# Access Compliance Report

## Public Rights-of-Way (Curb Ramps)

Intersection ID: 10040728	Main Street: N_SYCAMORE_ST	Cross Street: N/A	Location: NE
ADA ID: 02FD91D00A7B	Ramp Type: Directional1	Initial Pass/Fail: Fail	Overall Compliance: No
		Severity Score: 12.5

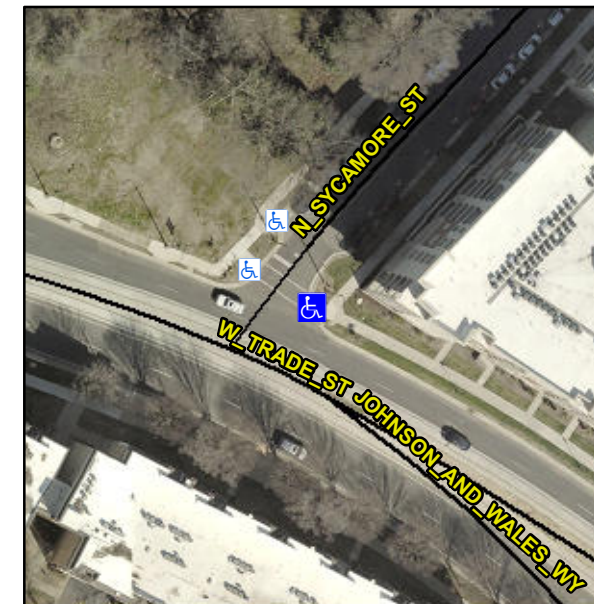
**R304.2.2**

Compliance	Description	Data	Compliance	Description	Data
N/A	Ramp Length (in)	69.0	N/A	Grade Break?	N/A
Yes	Ramp Width (in)	69.0	N/A	Grade Break Slope (%)	0.0
No	Ramp Slope (%)	10.1	N/A	Grade Break XSlope (%)	0.0
Yes	Ramp XSlope (%)	0.1			
N/A	Flare Type LT	N/A	N/A	Flare Type RT	N/A
N/A	Flare Slope LT (%)	N/A	N/A	Flare Slope RT (%)	0.0
N/A	Flare Traversable LT?	N/A	N/A	Flare Traversable RT?	N/A
N/A	Landing Length (in)	0.0	N/A	DWS Provided?	N/A
N/A	Landing Width (in)	0.0	N/A	DWS Contrast?	N/A
N/A	Landing Slope (%)	0.0	N/A	DWS Length (in)	N/A
N/A	Landing X Slope (%)	0.0	N/A	DWS Full Width?	N/A
N/A	Landing Curb? (Y/N)	N/A	N/A	DWS Offset LT (in)	N/A
N/A	Shared Landing?	N/A	N/A	DWS Offset RT (in)	N/A
N/A	Gutter Ponding?	0.0	N/A	Gutter Slope (%)	N/A
N/A	Gutter Lip Ht (in)	0.0	N/A	Gutter X Slope (%)	N/A
N/A	Painted X Walk1?	Yes		Road Slope (%)	4.8
	X Walk 1 Direction	To NW		Road X Slope (%)	1.6
	X Walk 1 Width (in)	100.0		Clear Space?	N/A

**Remove & Replace Entire Ramp.**
